RE: **Coors Pavilion Lot 4 (Panera Bread)**  
**4021 Coors Blvd NW**  
**Request for Certificate of Occupancy - Permanent**  
**Hydrology Final Inspection- Approved**  
**Engineer's Stamp Date: 5/31/17 (G11D069A)**  
**Certification Dated: 1/19/18**

Re: G11D069B – Lot 4 Coors Pavilion Subdivision Drainage Certification

CITY OF ALBUQUERQUE  
PUBLIC WORKS DEPARTMENT  
ENGINEERING DEVELOPMENT GROUP  
**COORS PAVILION SUBDIVISION**  
**LOT 4 & PORTION LOT 5**  
**GRADING & DRAINAGE PLAN**

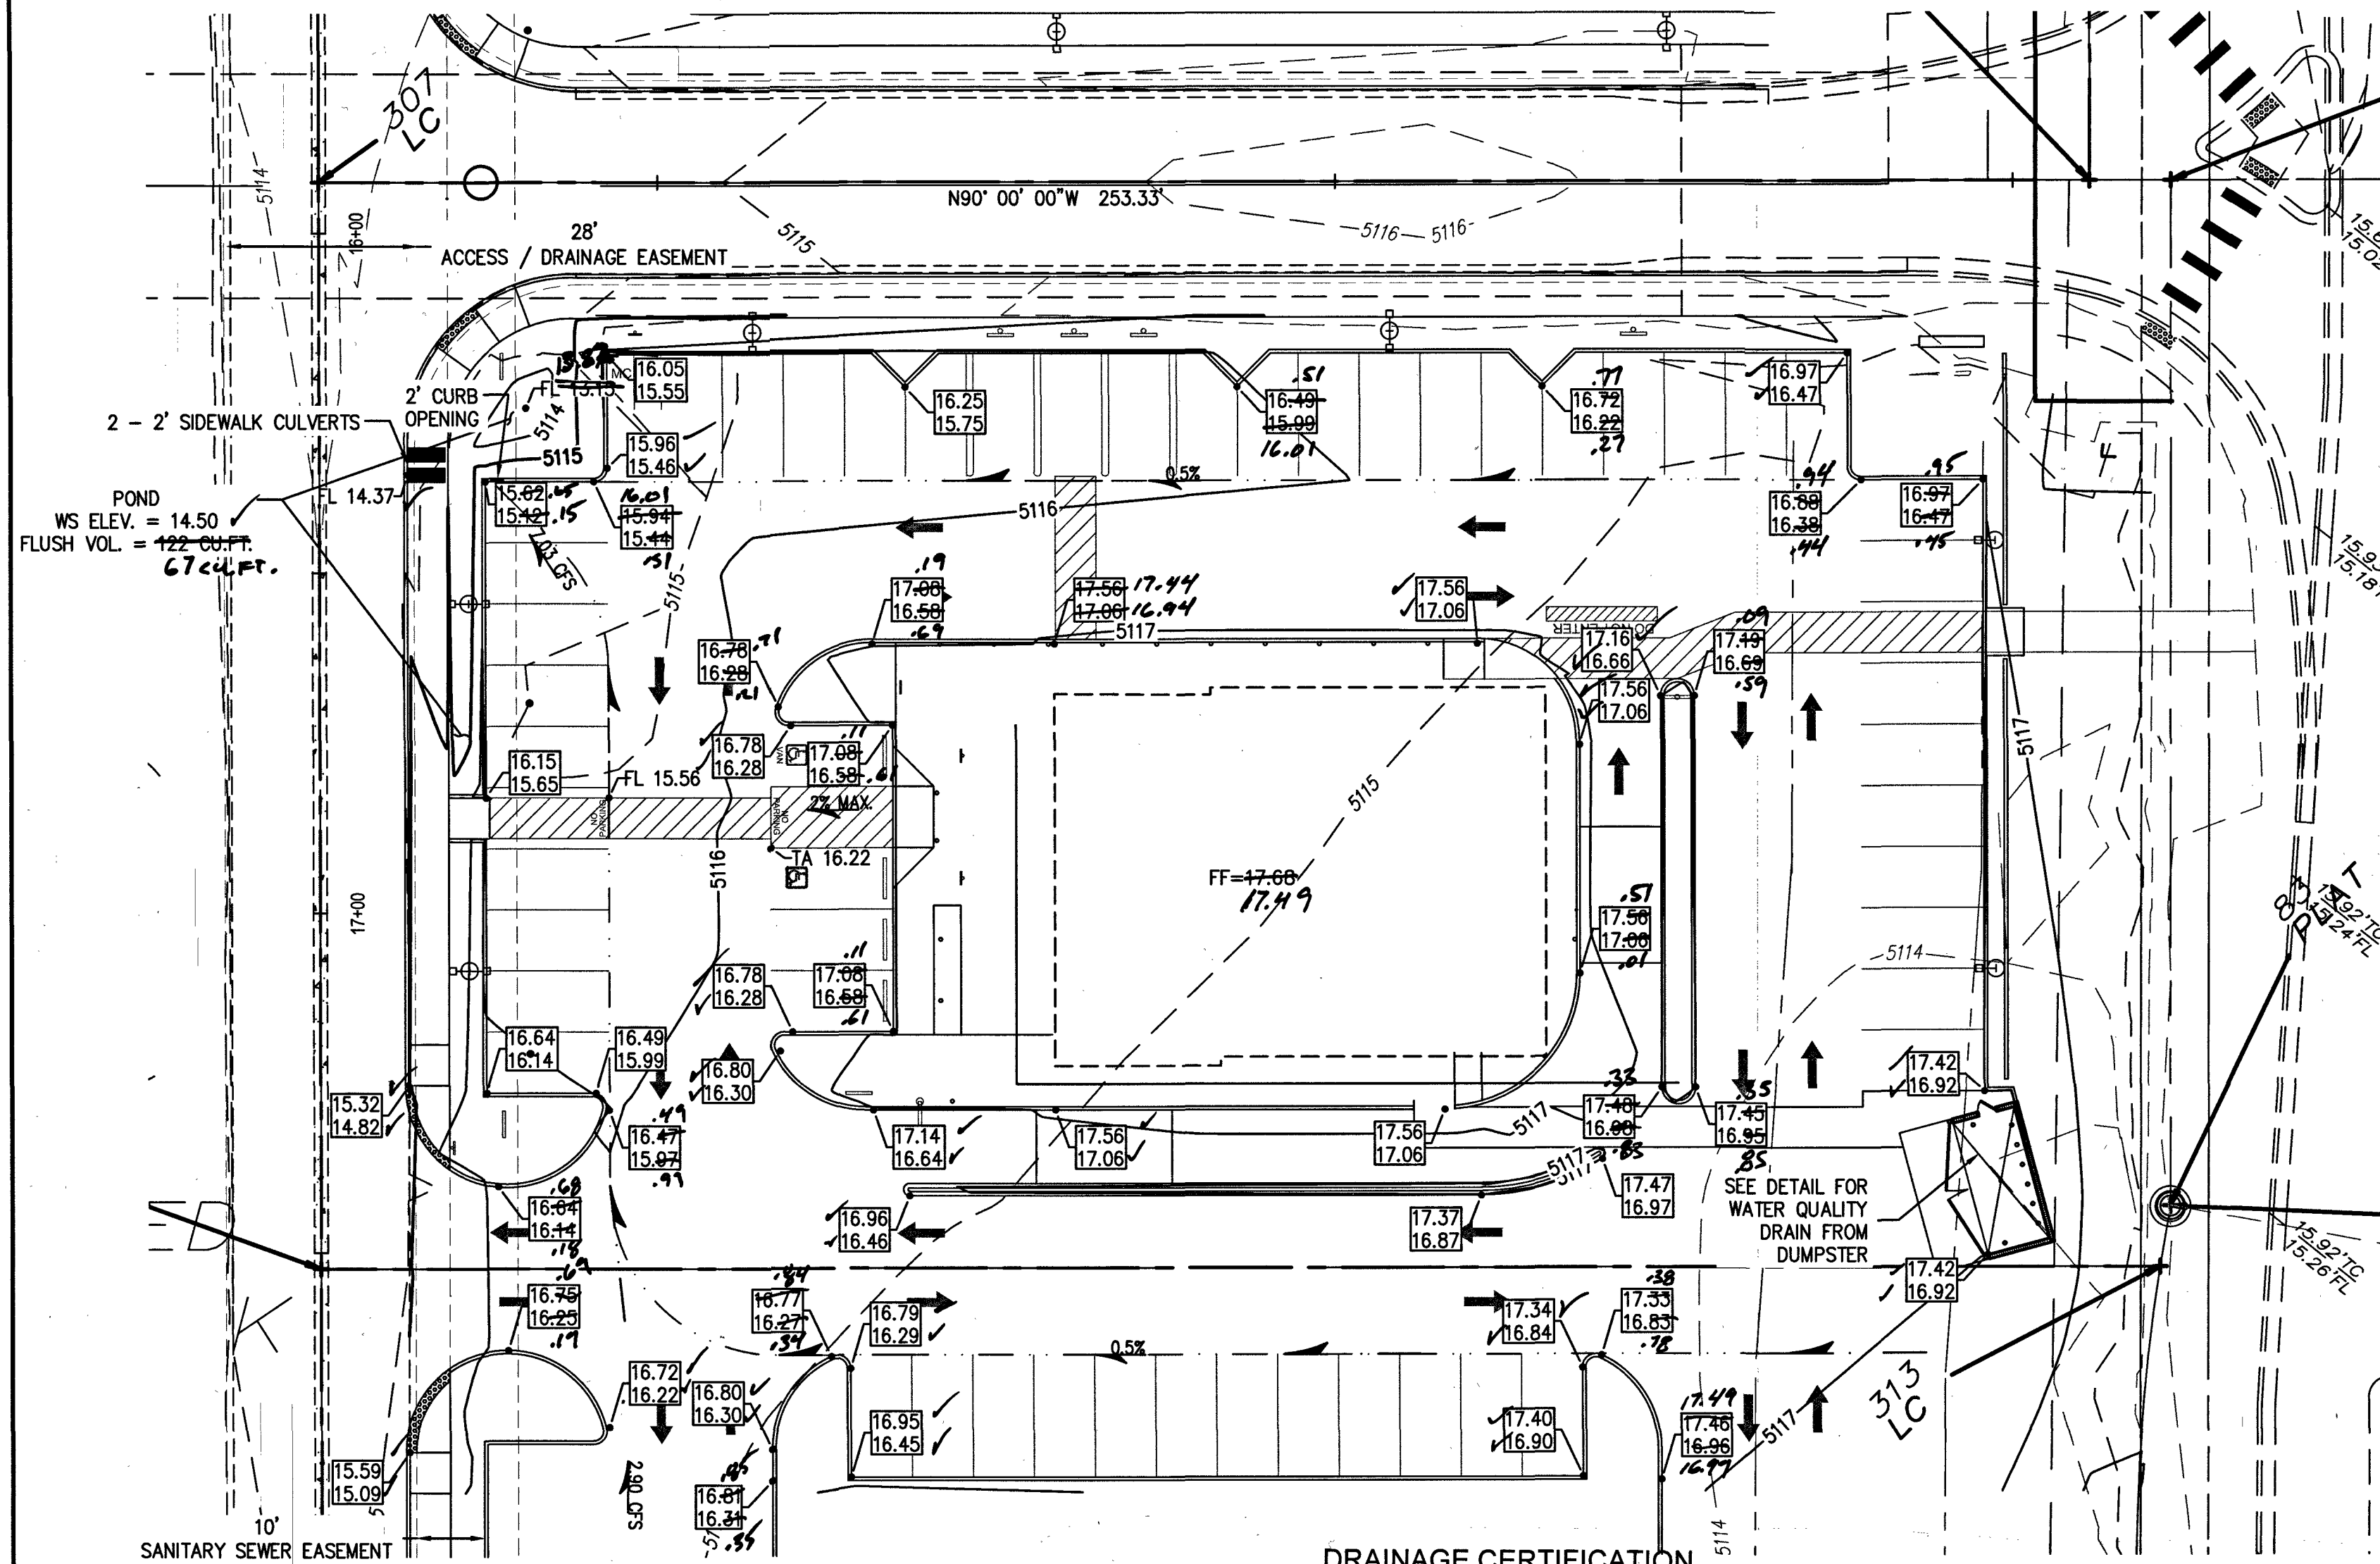
1. The steel rods have been ground smooth.
2. The plan depicts the modified volume of the first flush pond
3. A copy of the Utility Plan is attached.

REQUIRED VOLUME = 74,570 \* (0.44-0.10)/12 = 2,113 CU.FT.  
LOT VOLUMES PROVIDED = 122 CU.FT. **0.7 CU. FT.**  
VOLUME REQUIRED FROM SITE POND = 4,992 CU.FT. **2,947 CU. FT.**
